Design Considerations

COMMUNITY OUTREACH

Plaza Park, Village Park, Community Clubhouse
Fair Oaks Recreation and Park District

Concept Plan Alternative #1

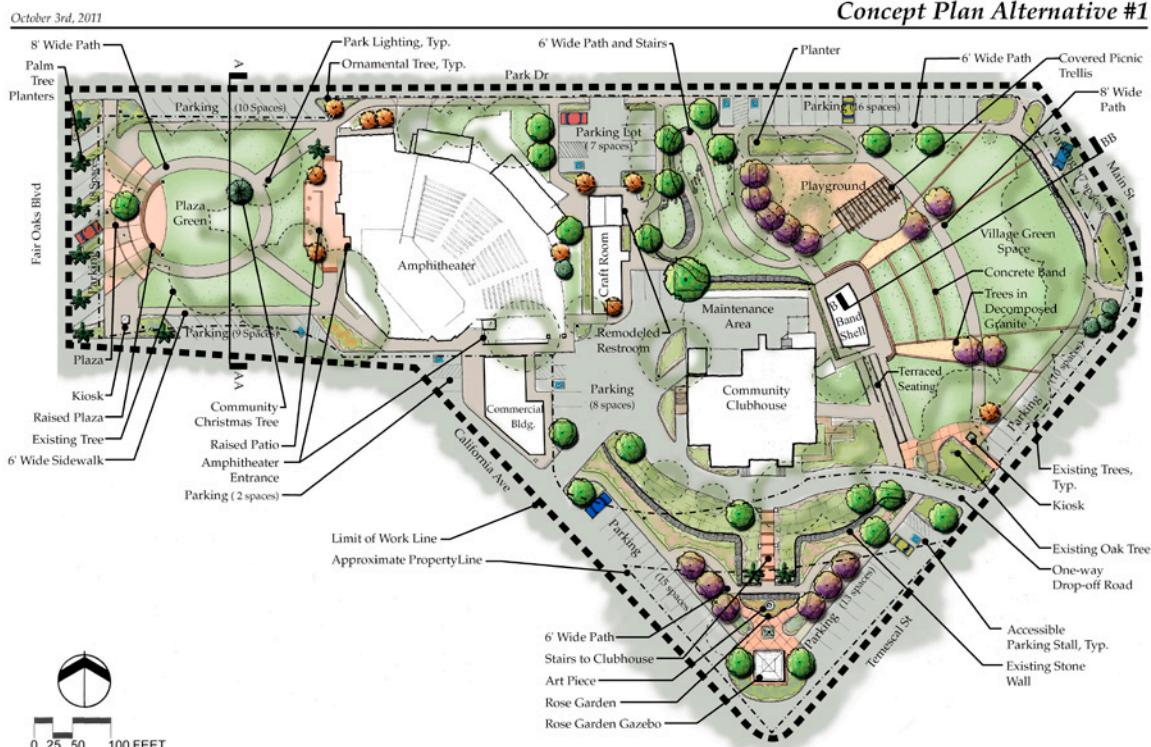
- Community preferred the traditional design style of Plaza Park.
- Do not raise the center of Plaza Park.
- Likes the parking reconfiguration in front of the Clubhouse.
- Wants trees preserved.

- Prefers the curved paths.
- Does not like the off-street parking lot.
- Would like a focal feature such as a fountain at Plaza Park.
- Remodel the existing restroom.
- Remove kiosk at corner of Temescal Street and California Avenue.
